Subject: Response to Request for Additional Information (RAI) Regarding the License Amendment Request to Revise the Fermi 2 Licensing Bases for Protection from Tornado-Generated Missiles

**Enclosure to
NRC-13-0053**

**Fermi 2 NRC Docket No. 50-341
Operating License No. NPF-43**

**Response to Request for Additional Information (RAI) Regarding the
License Amendment Request to Revise the Fermi 2 Licensing
Bases for Protection from Tornado-Generated Missiles**

Figure 2. RHR Complex Roof

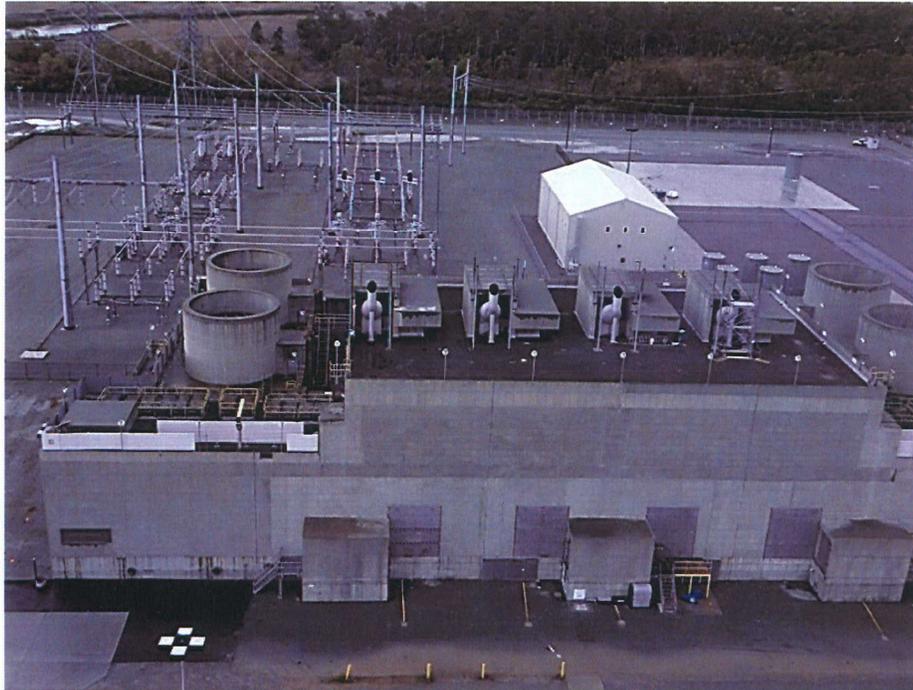
Are the vent stacks protected from horizontally traveling missiles? A missile traveling horizontally could crimp the vent to significantly reduce air flow and prevent the EDG fuel oil tanks and diesel engines from functioning properly.

Substantial tornado missile protection of the EDG fuel oil tank vents and the EDG exhaust stacks exists by virtue of the immediate adjacent reinforced concrete enclosures and the elevated location on the roof of the RHR complex (Figures 2 through 4). The safety-related EDG exhaust silencers are enclosed on the top and three sides (North, South, and West) by thick reinforced concrete enclosures which protect the exhaust penetrations from tornado missile strike. The attached non-safety related exhaust extensions (stacks) that extend beyond the silencers have been analyzed to ensure that they can withstand tornado winds and to verify compliance to seismic II/I criteria such that they will not crumple and crimp to block diesel exhaust flow. As provided in the list of excluded targets in Enclosure 4 of Reference 2, for targets 41 through 44 and 75 through 78, the configuration of the EDG exhaust stacks, fuel oil tank vent stacks and associated missile protection barriers are part of the original plant licensing bases.
